SUBJECT: RECALL R05JN INADVERTENT ENGINE SHUTDOWN

Inadvertent Engine Shutdown

MODELS AFFECTED: All Blue Bird Visions delivered through March 01, 2005

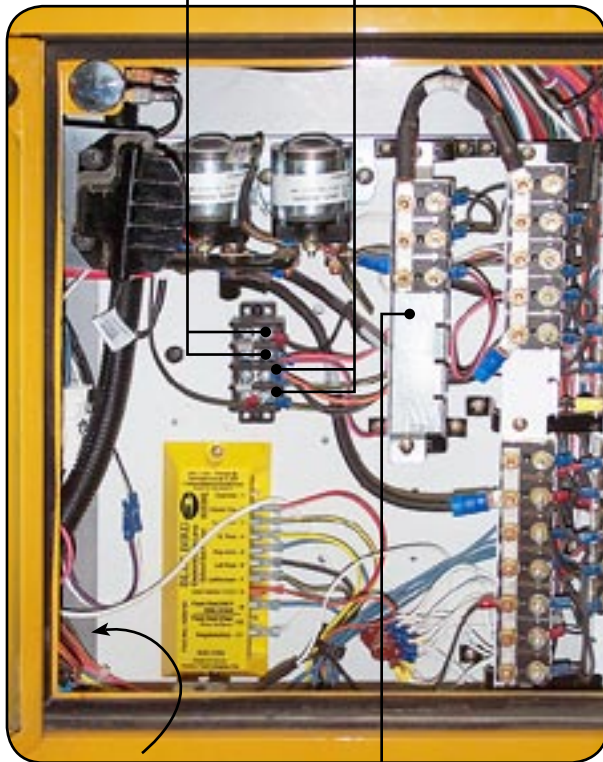
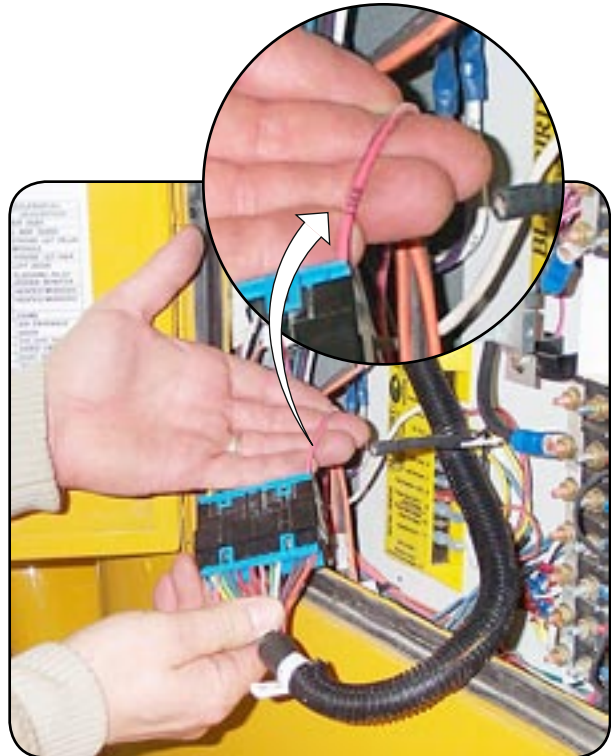
The wire numbered 1168 will be entirely removed from the harness and discarded.

All other wires connected to these two terminals will be relocated to a new breaker.

New breaker will be installed here, with relocated accessory wires attached.

3 Completely remove the wire labeled 1168 as follows:

3.1 Locate the body harness connector block near the lower front corner of the panel. Locate the pink wire with black tracer, labeled 1168.

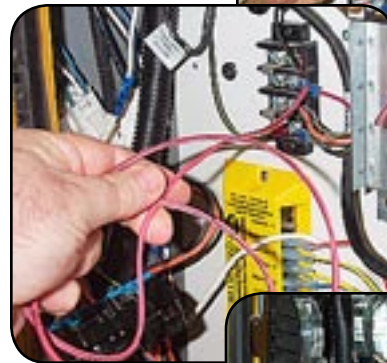
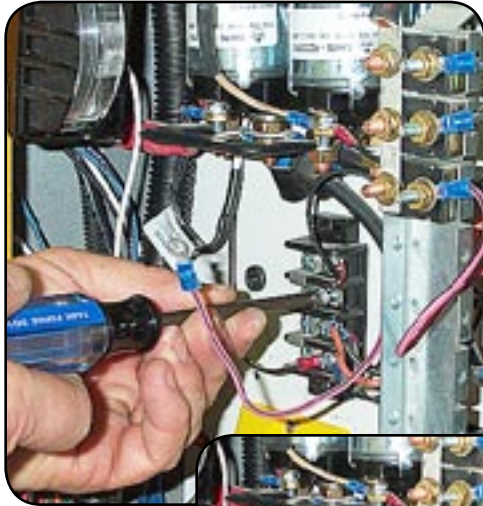
3.4 Clip the terminal pin off the end of the removed wire. Then pull the wire from the terminal strip end to remove it from the wiring bundle. With the wire completely free, remove its ring terminal from the ignition terminal block and discard the wire.

Clip the terminal pin off the removed wire. . .

. . . pull wire out from opposite end. . .

. . . remove from terminal block and discard the wire.

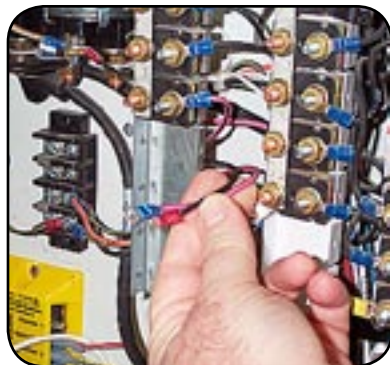
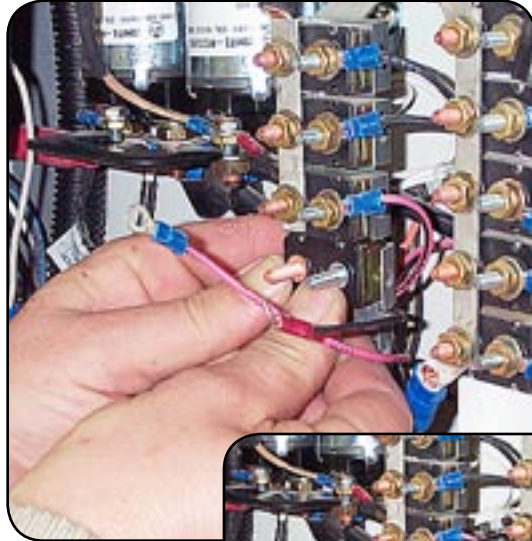
4 On school buses, the two top terminals of the T/S 1 Terminal Block may have additional wires attached, depending upon optional equipment installed. Disconnect any wires from these two terminals and route them behind the Circuit Breaker Bracket as shown:

Remove all wires from the top two terminals...

...and route them behind the Circuit Breaker Bracket.

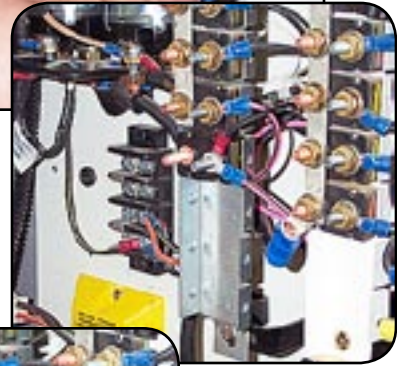
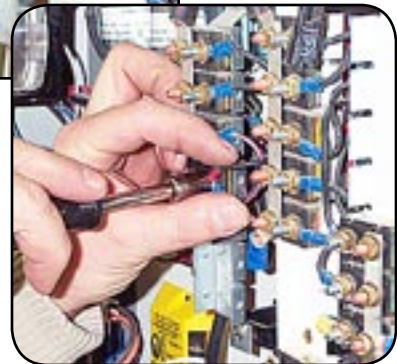
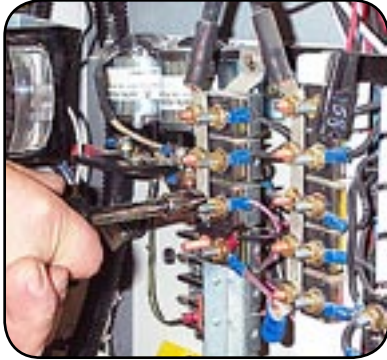
5 Mount a new 15 amp breaker (2006104) in the first available slot of the Circuit Breaker Bracket, with the copper coated stud (labeled "Bat") toward the front of the vehicle. Attach all of the relocated wires from step 4 to the new breaker's silver colored stud (labeled "Aux"):

Install a new 15 amp breaker. Install all wires removed in step 4.

Install plain washer, lock washer, and nut.

Tighten securely with wires spread radially to avoid stacking of the crimped ends.

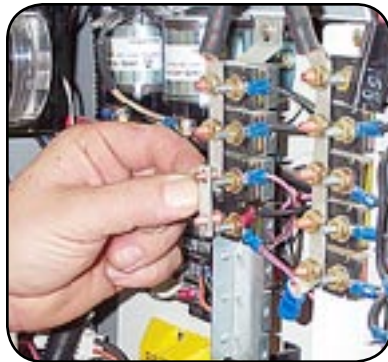
6 Install a new hot bar connector (2006096) to bridge the new breaker with the breaker above it:

Remove nut from left (hot side) terminal of the first breaker above the new breaker.

Install hot connector bar (2006096).

Install plain washer, lock washer, and nut. Tighten securely.

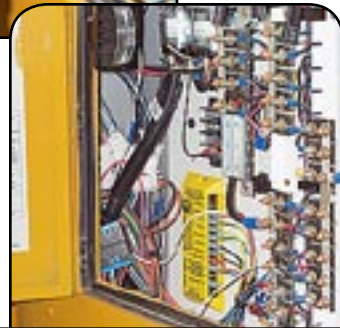
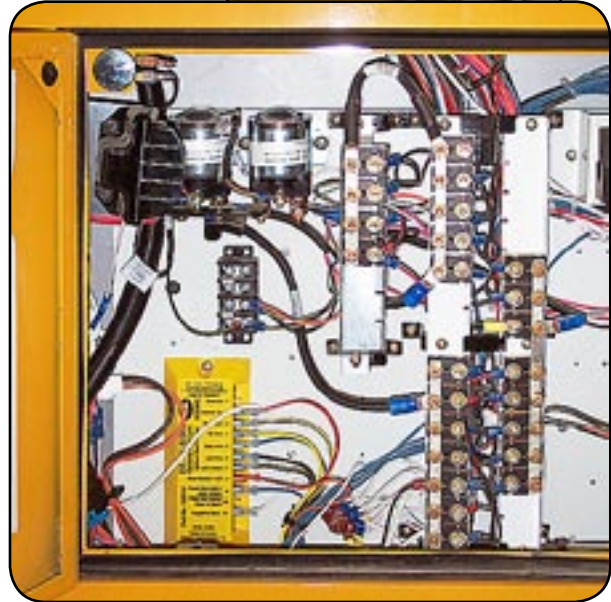
7 Reconnect body harness and place it back in its original position. Close door and reconnect batteries.

Reconnect body harness.

Replace harness connector in original position at lower left of panel.

Finished modification.
